GLOBAL SAFETY FIELD INVESTIGATIONS
DCS5335
URGENT - DISTRIBUTE IMMEDIATELY

Subject: N192287890 - Service Update
Dash Panel Silencer Attachment Stud Lacks Clearance

Models: 2020 GMC Acadia equipped with:
2.5L DOHC 4-CYL SIDI W/ Variable Valve Timing (RPO LCV)

N192287890 Dash Panel Silencer Attachment Stud Lacks Clearance

5515714

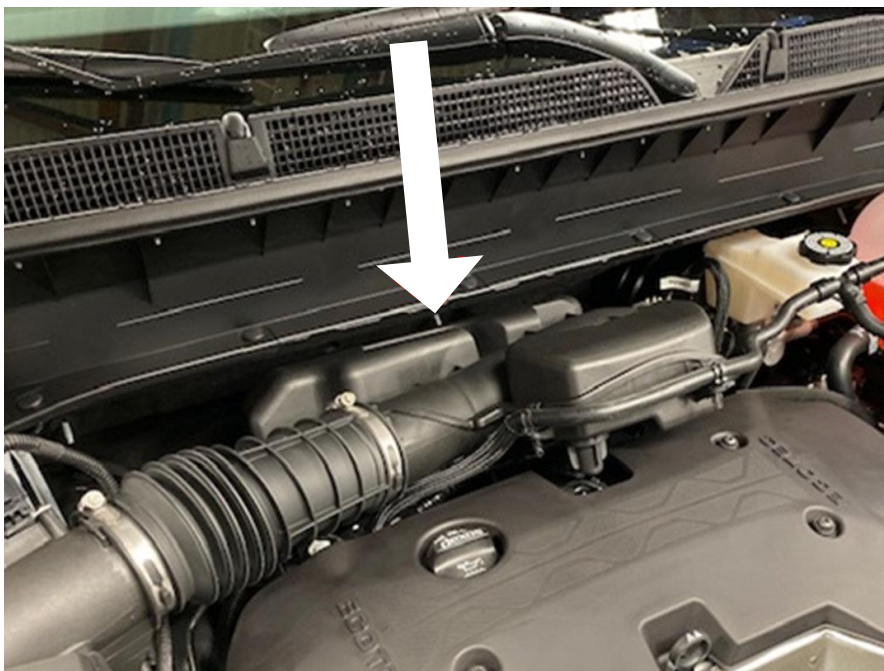
Condition	On certain 2020 model year GMC Acadia vehicles, equipped with a 2.5L engine (RPO LCV), the dash panel silencer attachment stud may lack sufficient clearance to the intake manifold resonator. When the engine is under load, the stud could make contact with the resonator.
Correction	Dealers will cut off 6mm of the center stud.

2. Locate the dash pad silencer stud as shown. Side view shown above for reference.
3. Using bolt cutters, cut the stud flush with the dash pad silencer fastener.
4. Apply anti-corrosion coating to the exposed end of the stud where it was cut. Refer to *Anti-Corrosion Treatment and Repair* in SI.
5. Remove fender covers and close hood.
